# UNITED STATES PATENT AND TRADEMARK OFFICE

10/668,659

| <b>Office Action Summary</b> | <b>Application No.</b><br>10/668,659 | <b>Applicant(s)</b><br>PARK, JOON |  |

- 1) ☒ Responsive to communication(s) filed on 17 March 2006.  
 2a) ☒ This action is **FINAL**. 2b) ☐ This action is non-final.  
 3) ☐ Since this application is in condition for allowance except for formal matters, prosecution as to the merits is closed in accordance with the practice under *Ex parte Quayle*, 1935 C.D. 11, 453 O.G. 213.

Fig. 1.

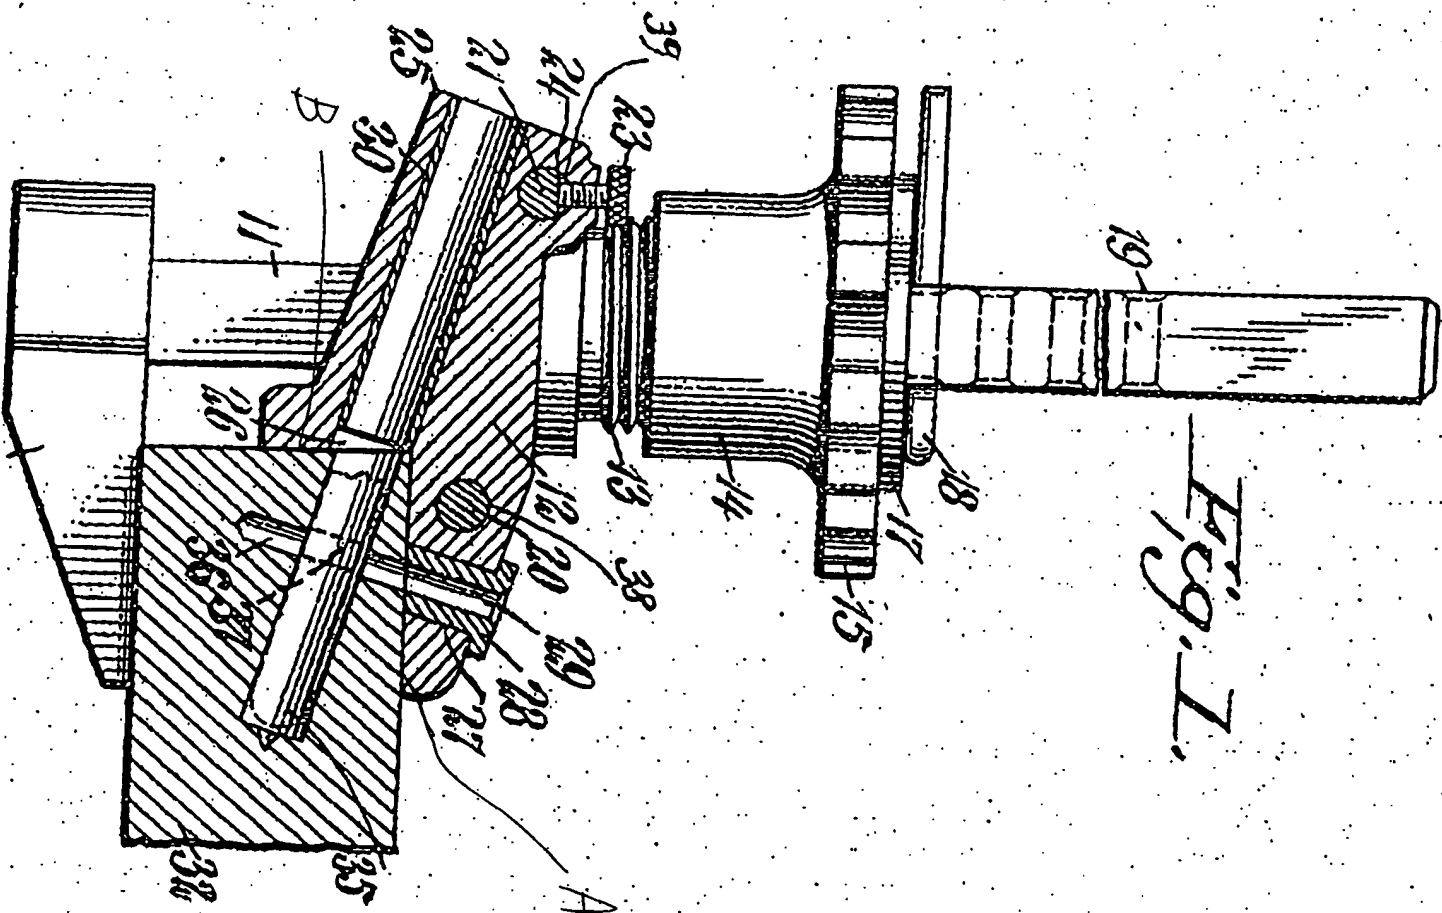
The examiner has attached an enlarged copy of figure 1 of Godefroy et al. The clamp surface adjacent bushing 28 has been labeled “A,” and the clamp surface adjacent bushing 30 has been labeled as “B.” Analyzing claim 1, the guide carrier 22 of Godefroy et al does not move perpendicular to either of surfaces A or B; the guide carrier moves parallel to either of the surfaces. Thus, Godefroy et al does not meet the limitation of line 19 of claim 1.
